CAPP 2010-0002

Madison

New Residential Construction (deferred from April 12, 2010)

Waterford Historic District

PRINCIPLE ARCHITECTURAL ISSUES

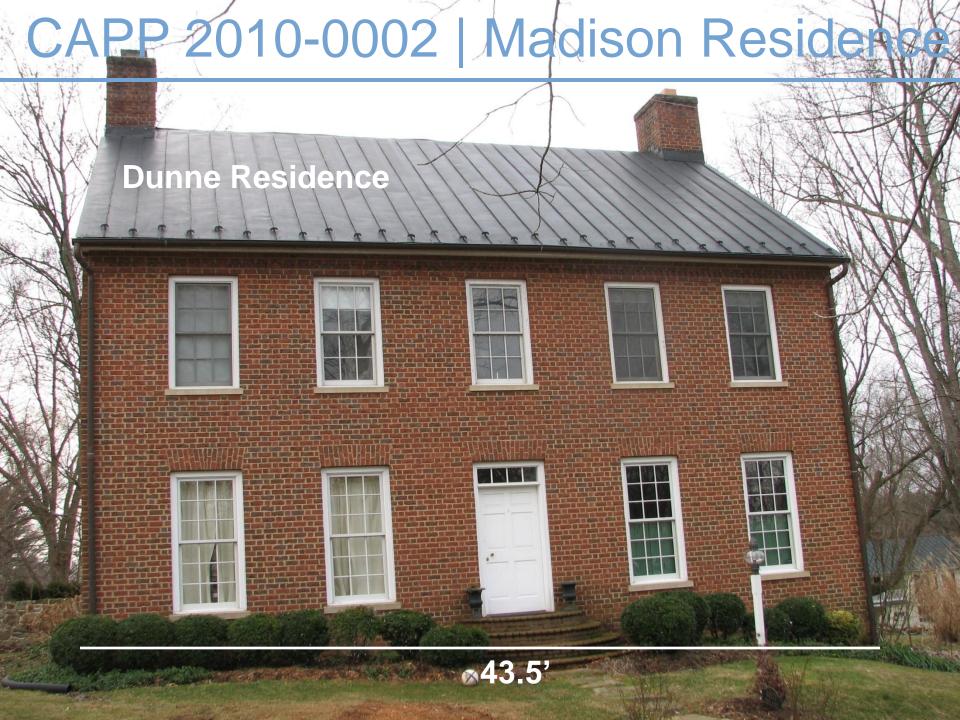
Ongoing application issues with revised application:

- 1.) Scale, width, & massing larger than historic precedents,
- 2.) Depicted grade change not accurate,
- 3.) Incomplete detailed drawings of architectural elements,
- 4.) Incomplete materials list.

DETAILS

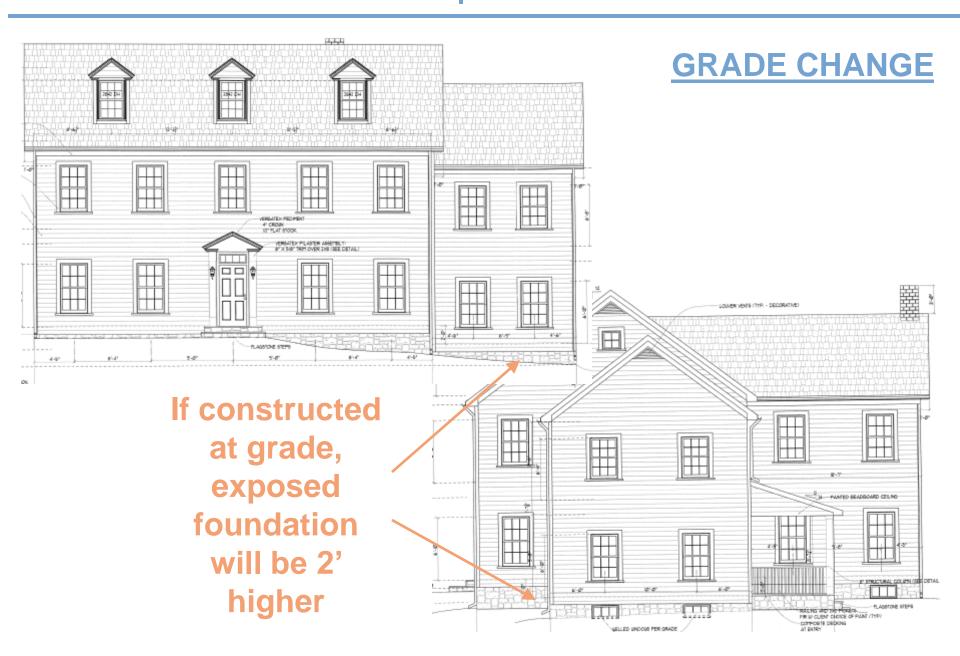
- Brick pattern and details
 - Jack arches
 - Cornice
- Door and window trim
- Porch details
- Shutters

In general, the materials and details should be in keeping with the simple, yet formal, style of the proposed house to meet the Guidelines.
